# FINAL DRAINAGE REPORT

**FALCON RANCHETTES FILING NO. 2**  
**MERIDIAN STORAGE**  
El Paso County, Colorado

VR239 and PPR2336

DATE:  
**April 24<sup>th</sup>, 2023**

Figure 3-2  
 Drainage Basin Map  
 Falcon DBPS  
 El Paso County, CO

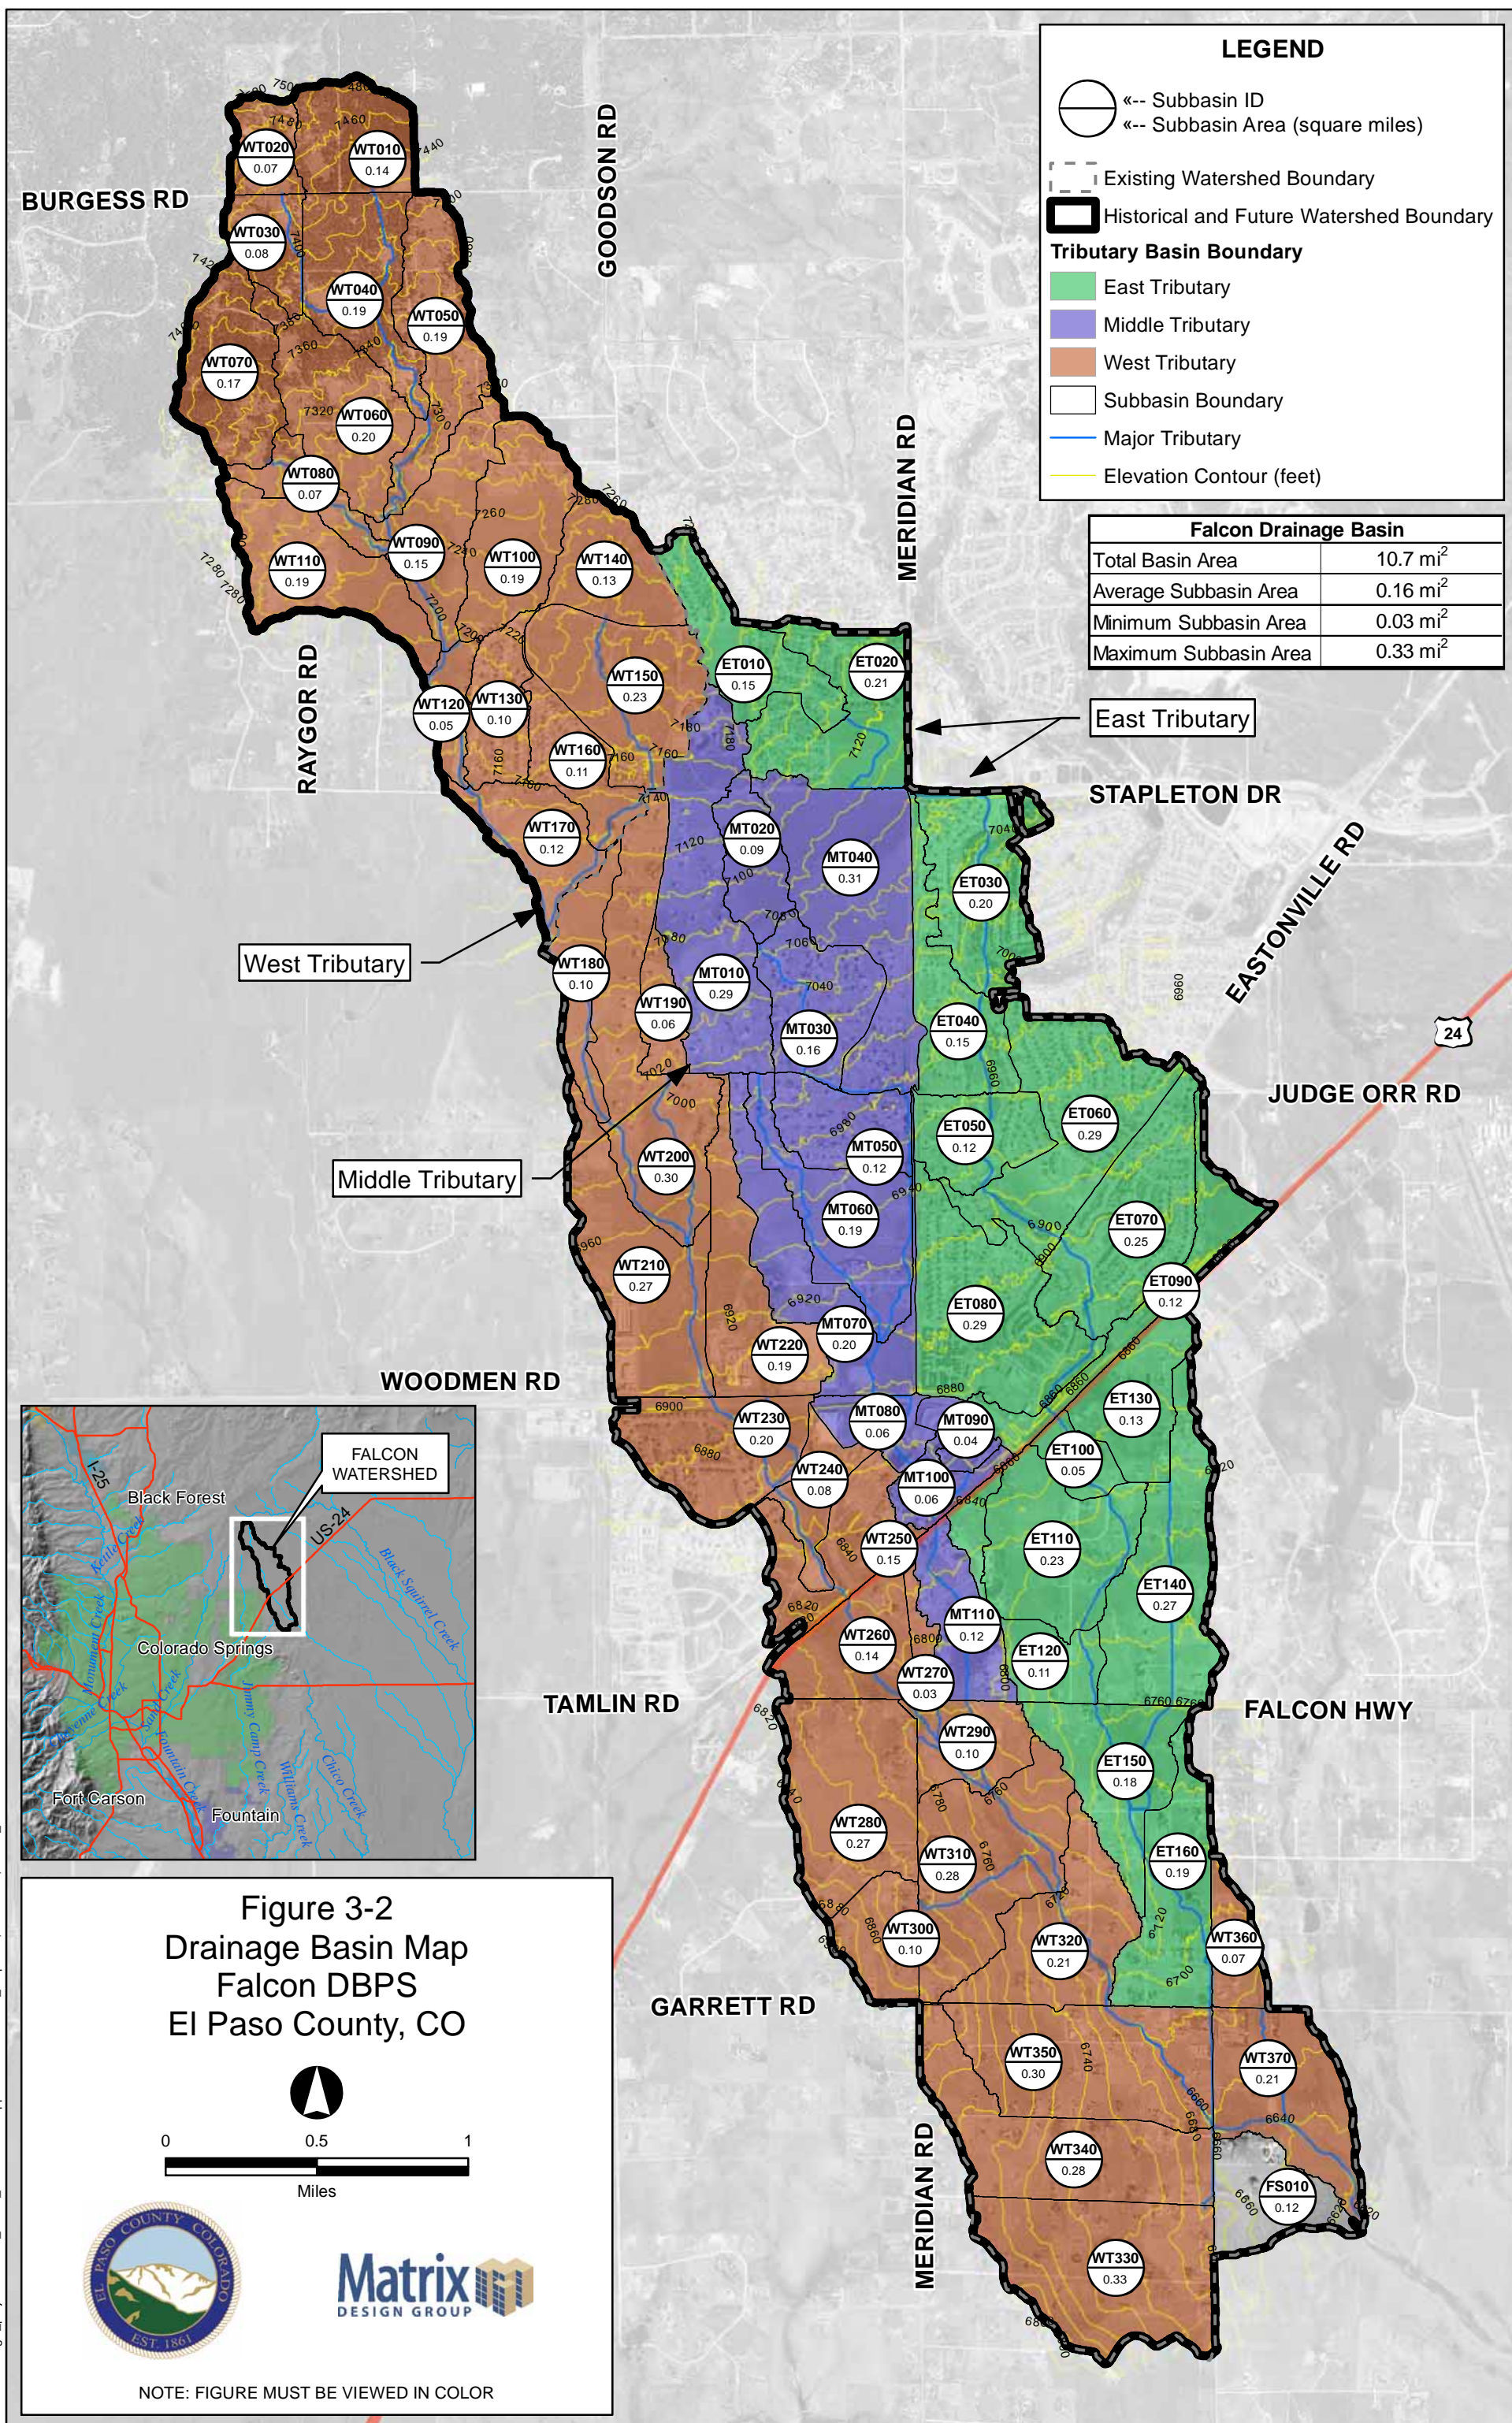
Fix figure - entire background show up as black making the figure difficult to read.
